**78-90 OLD CANTERNBURY ROAD, LEWISHAM
SECTION 75W – AMENDMENT TO CONDITIONS 11 OF CONCEPT APPROVAL MP08-0195)**

In accordance with Section 75W of the Environmental Planning and Assessment Act 1979 (as amended from time to time), a modification is sought to amend Condition 11 of MP08-195 ("Concept Approval") to allow for the inclusion of "through site links" and "drainage reserves" as part of the approved Central Open Space.

LEWISHAM ESTATE DRAINAGE WORKS

PROPOSED SCHEME CENTRAL GREEN
SOFT LANDSCAPING AREA DIAGRAM

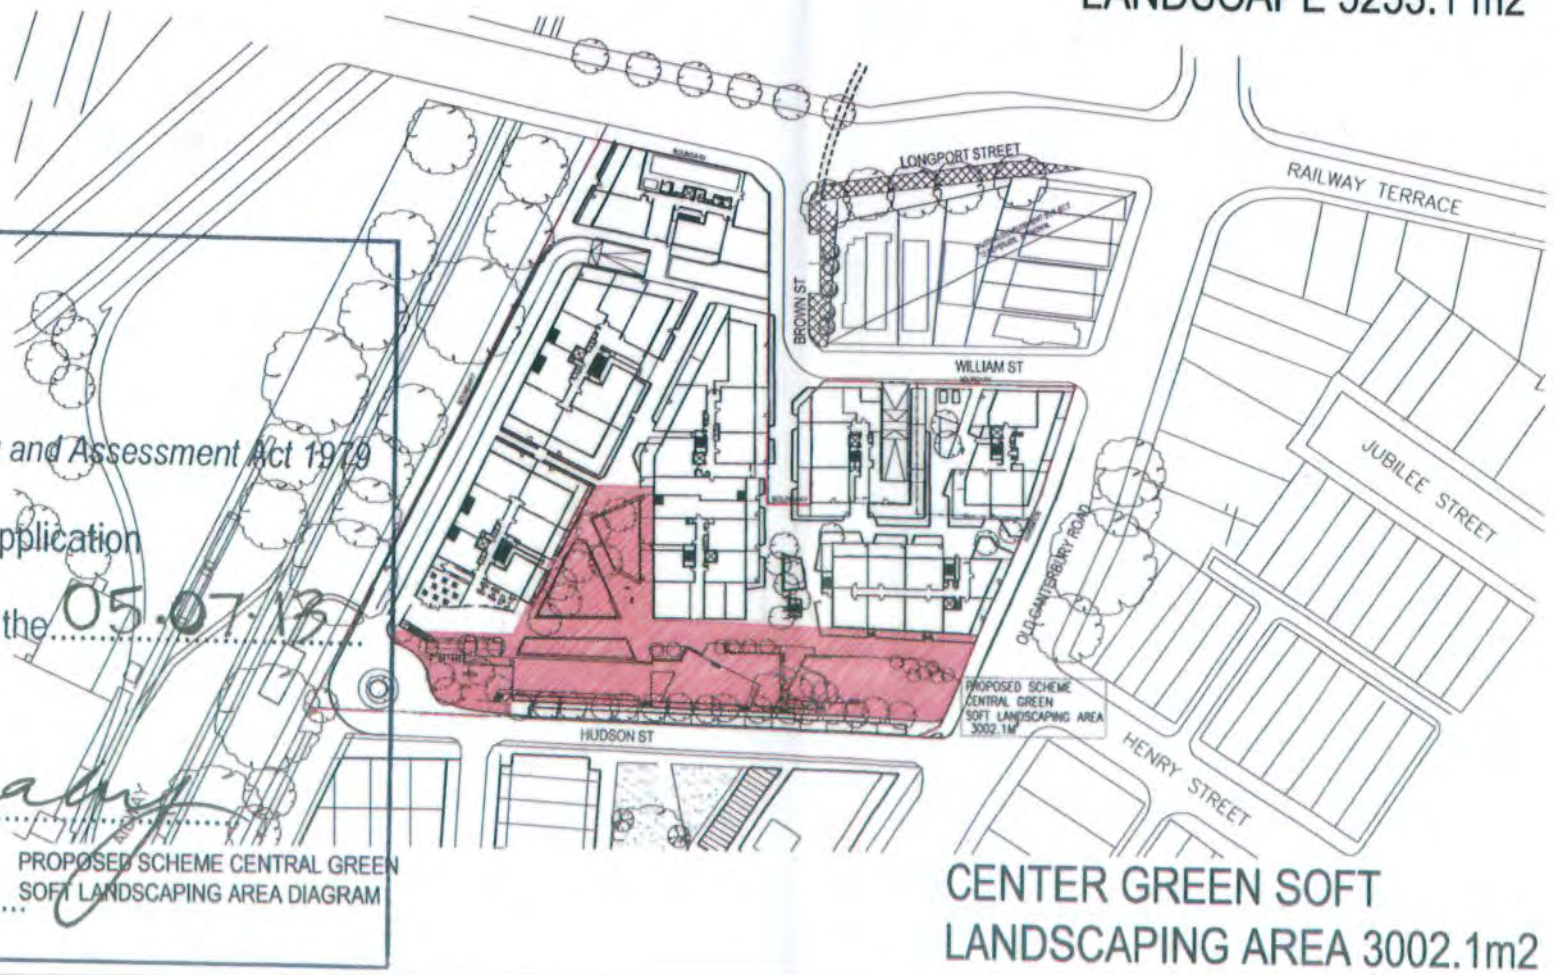
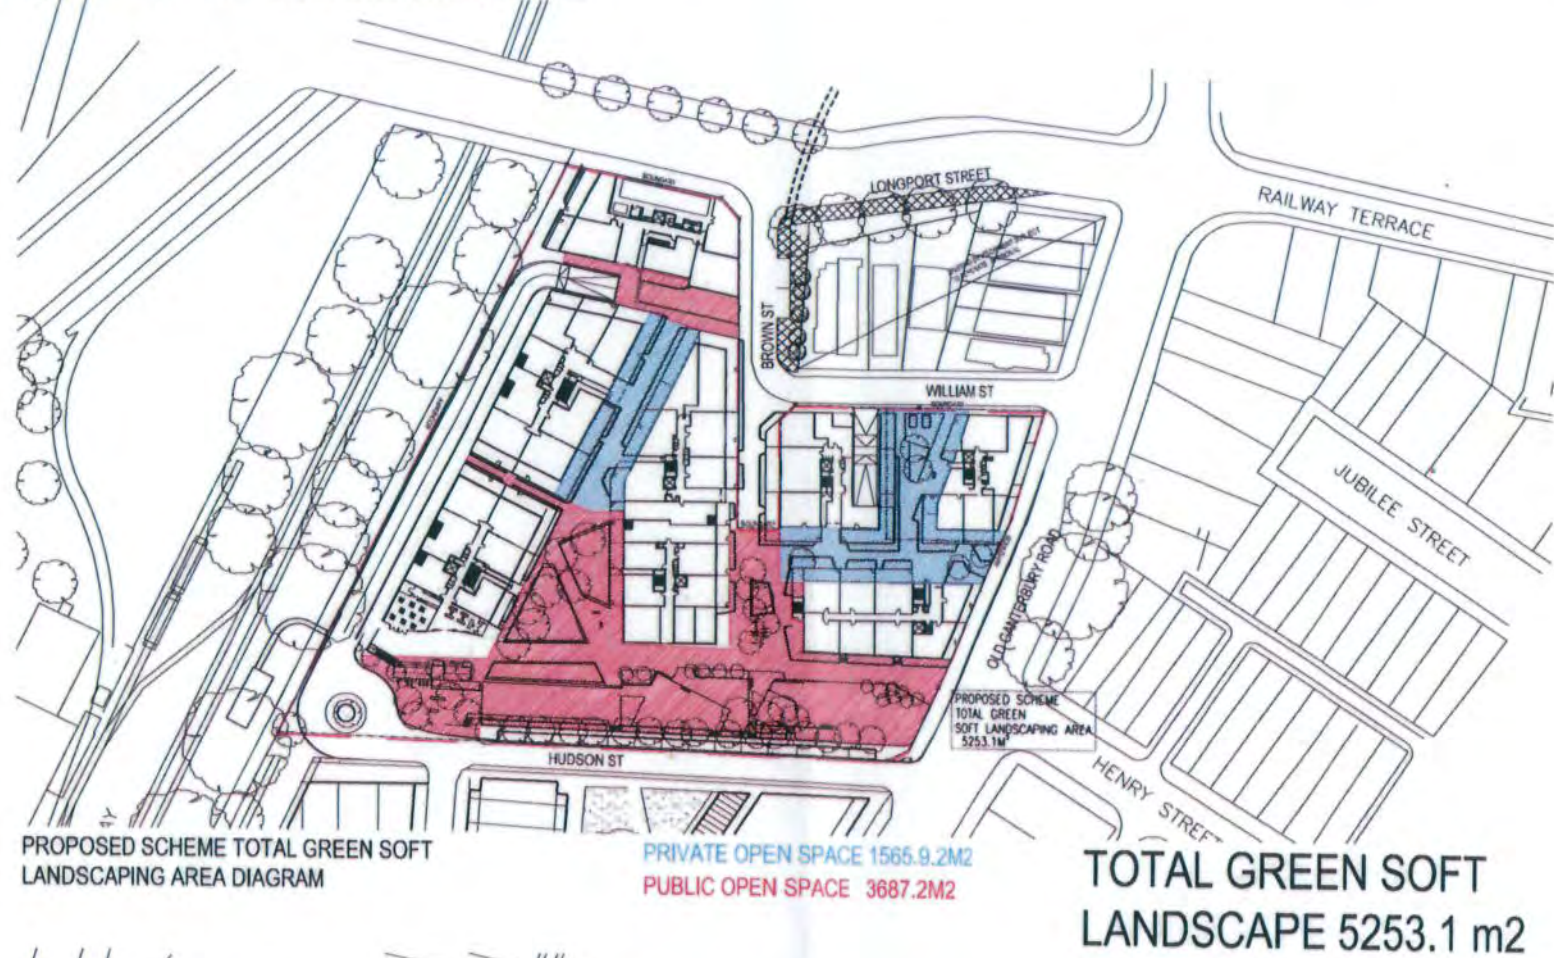
Currently, the condition does not permit the inclusion of "through site links" in the Central Open Space which is ambiguous given what is shown in the approved Green Space Calculation Analysis plan (refer to **Annexure 1**). The approved plan includes the major pedestrian/cycle link along the northern boundary of the central open space as well as other links between building A and C that will facilitate through-site access. In addition, the underlying purpose of the Central Open Space as per Section 9.45 of Council's Development Control Plan (DCP) is to provide a thoroughfare to the future light rail station. Accordingly, we seek a change to the condition to clarify that "through site links" can be included in the proposed Central Open Space provision.

11. *Future Development Applications shall provide a minimum of 3,000m² of publicly accessible open space. Through site links and drainage reserves ~~should not~~ shall be included as open space provision. All public and private open spaces shall be clearly defined and functions identified."*

Figure 6 - Upgraded Drainage Network

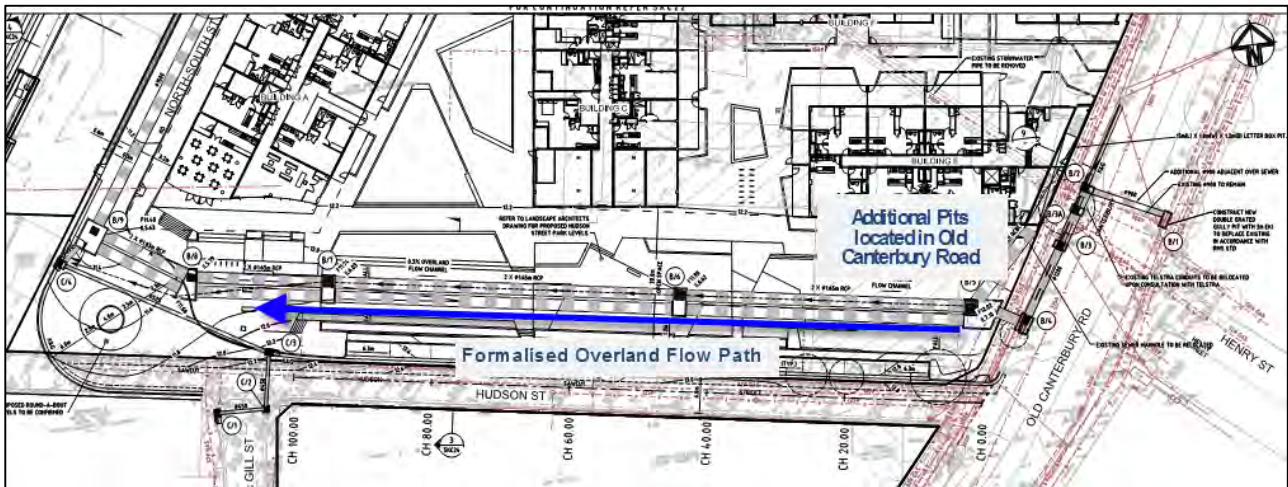
The proposed development of Lewisham Estate seeks to upgrade the trunk drainage system that presently flows through the site and provide a formal overland flow path which will minimise the risk of damage to property and risk to people (**Figure 6**). The proposed upgrade of the system is consistent with the intent of the 2005 Floodplain Development Manual and Council's DCP 2.22 and will provide a benefit to the present and future community.

The development of Lewisham Estate provides an additional two stormwater pits in Old Canterbury Road enabling water that previously ponded on Old Canterbury Road to access the upgraded trunk drainage system. The existing pipes that flow under buildings will be replaced by larger pipes that will be located under the proposed open space/overland flow path area parallel to Hudson Street (**Figure 6**), detailed drawings of the upgraded stormwater network are provided in Appendix A).

Figure B8 100 YEAR ARI PEAK DEPTH
SCHEME D1(Pit Blockage)

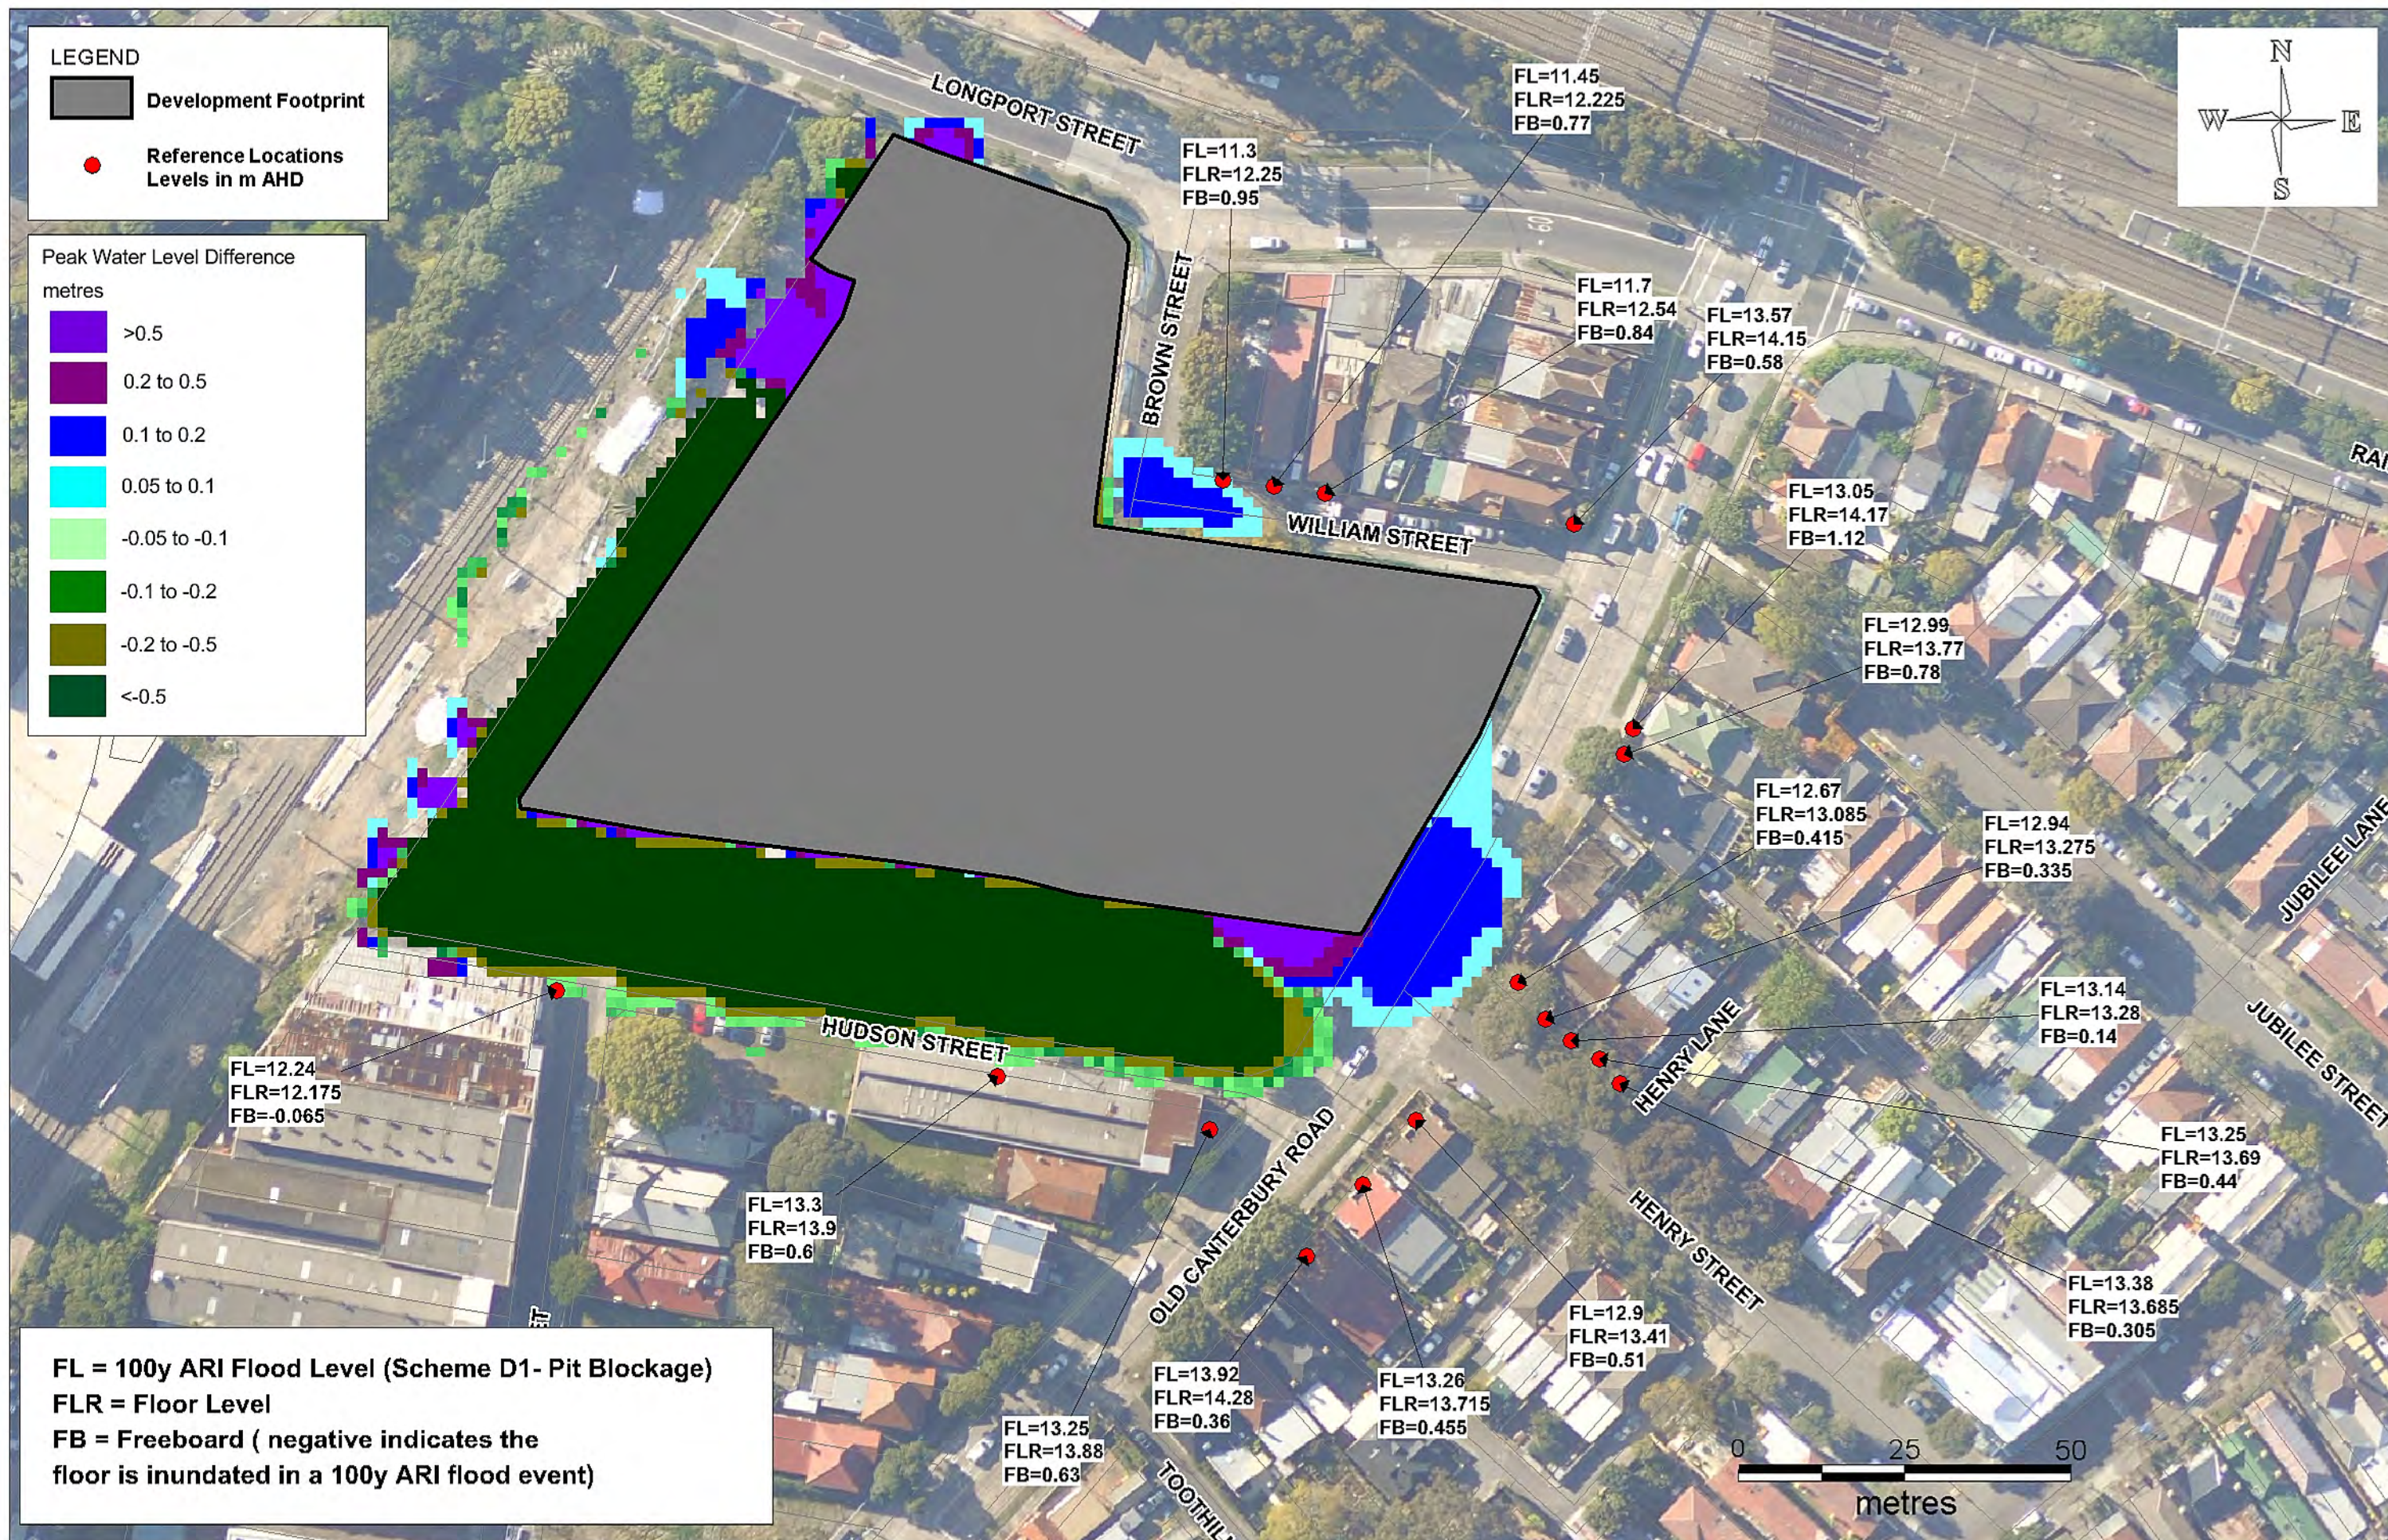
The estimated 100 year ARI flood extents and depths are shown in **Figure B8**. Flood level differences in comparison with the 100 year ARI flood levels are given in **Figures B9**, the 20 year results are shown in **Figure B10** and **B11**. The results show:

- The proposed scheme results in a local increase in the peak 100 year ARI flood level in Old Canterbury Road of 0.1 m ie. from 12.4 m AHD under Existing Conditions to 12.5 m AHD under Future Conditions. This impact does not extend to any buildings and does not result in any additional over floor flooding;
